Phase I Inspection Report

Mt. Beacon Reservoir

PHASE I INSPECTION REPORT
NATIONAL DAM SAFETY PROGRAM
MOUNT BEACON RESERVOIR DAM
I.D. NO. N.Y. 26
D.E.C. NO. 537
HUDSON RIVER BASIN
DUTCHESS COUNTY, NEW YORK

Date of Inspection: July 24, 1980

3. VIEW OF SPILLWAY AND DOWNSTREAM OF DAM.
NOTE: VEGETATION AT TOE OF DAM.

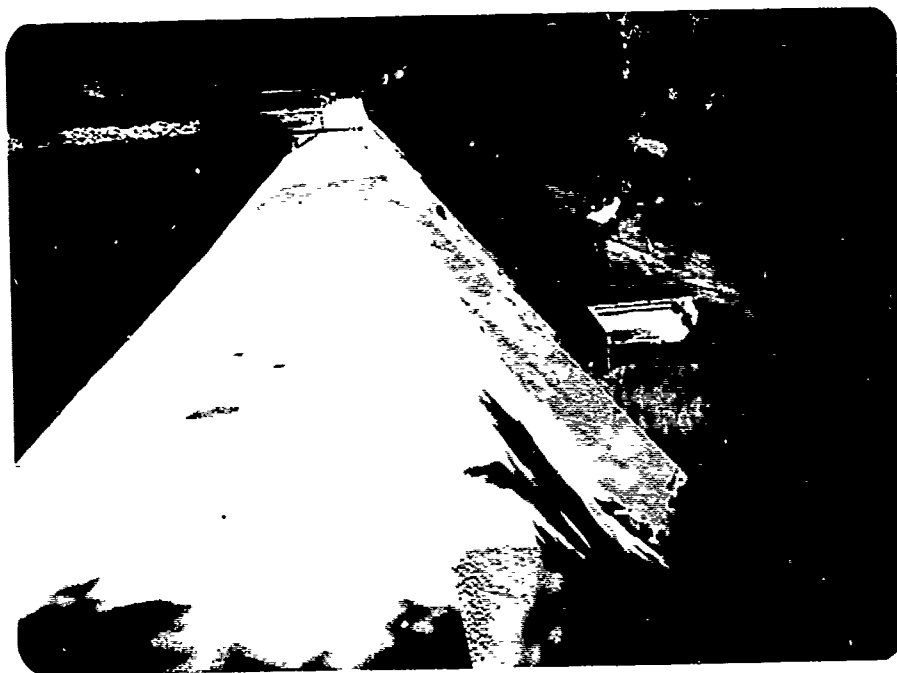
4. Remove the vegetation in the spillway channel and the area downstream from the toe of the dam. Provide a program of periodic cutting and mowing of these areas.

The entire area downstream from the toe of the dam is covered with overgrown grass, bushes and saplings (See Photograph No. 3).
